28 August 2015

Edition 17

AUSTRALIAN NOTICES TO MARINERS

Notices 912 - 984

© Commonwealth of Australia 2015
Block for Chart Aus 539 (53.3 X 64.8mm)

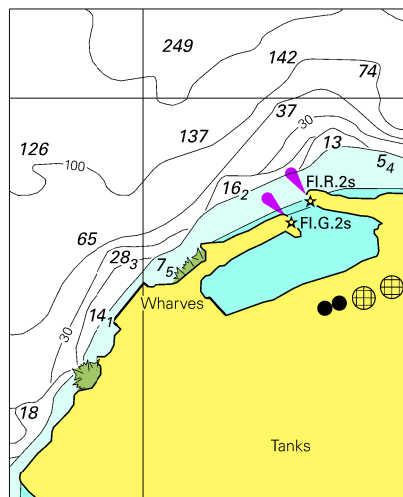
Aus 539 (plan, Luise Harbour) [1300/2010]

Insert	accompanying block	3° 07'.20 S	152° 39'.10 E
--------	--------------------	-------------	---------------

Block for Chart Aus 646

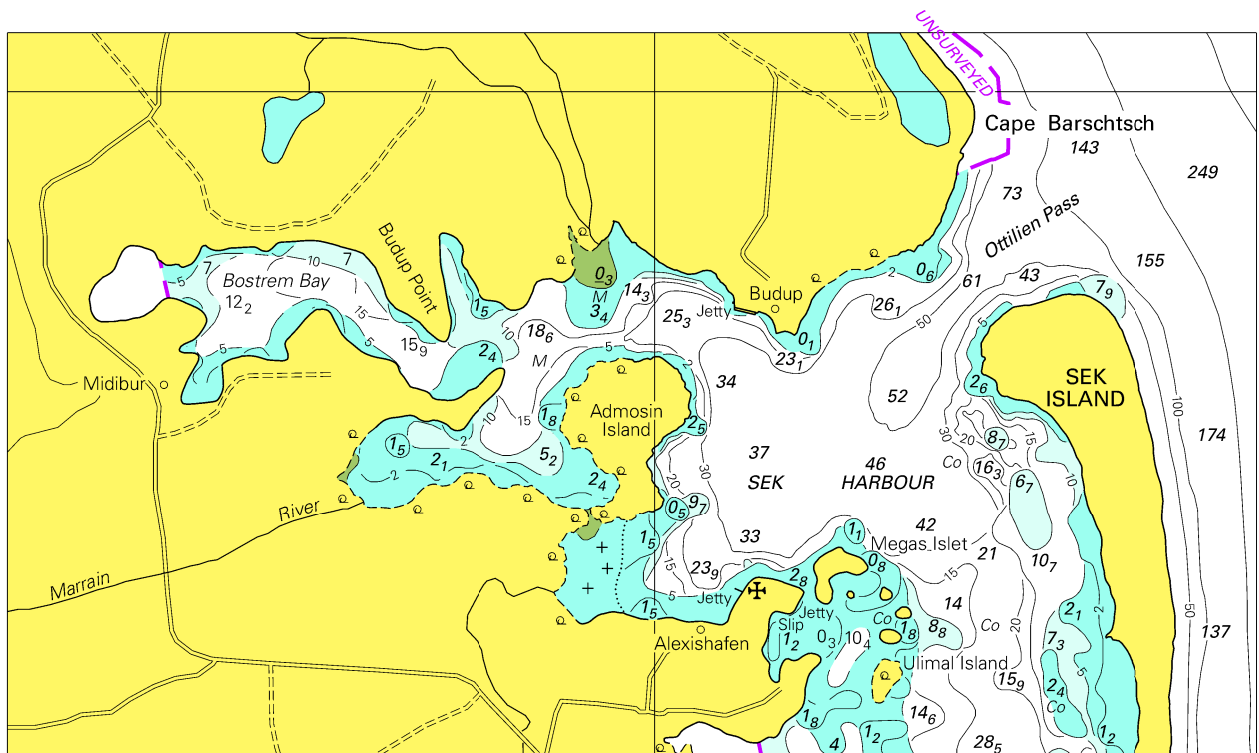
Aus 646 [612/2015]

Insert	accompanying block	5° 05'.00 S	145° 48'.00 E
--------	--------------------	-------------	---------------

To accompany Australian Notice to Mariners 937/2015

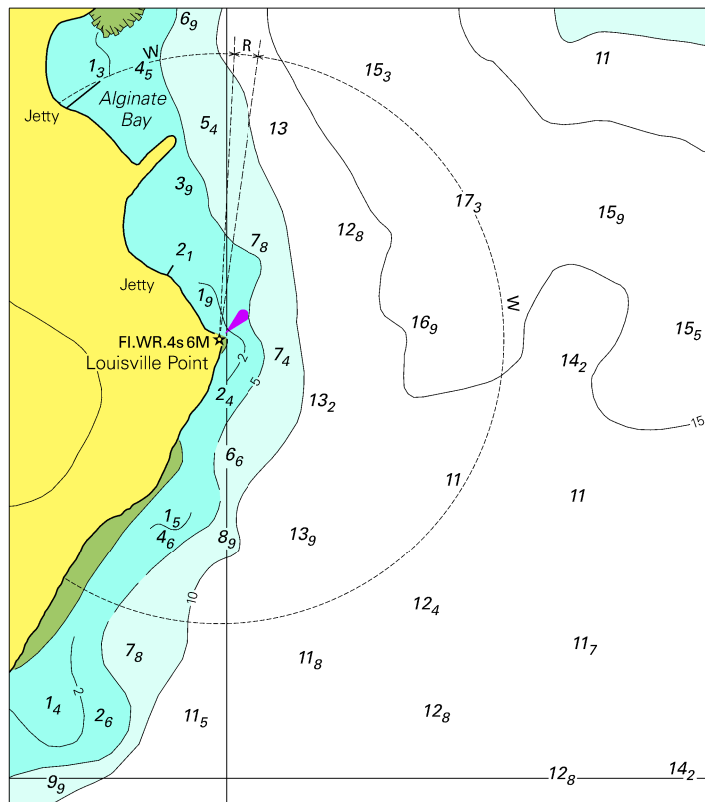
Aus 175 [238/2015]

Insert	accompanying block	42° 32'.60 S	147° 55'.00 E
Move	light	42° 31'.212 S	147° 55'.043 E
	to	42° 31'.199 S	147° 55'.050 E
Delete	continuous line, between	42° 31'.21 S	147° 55'.04 E
		42° 31'.20 S	147° 55'.05 E
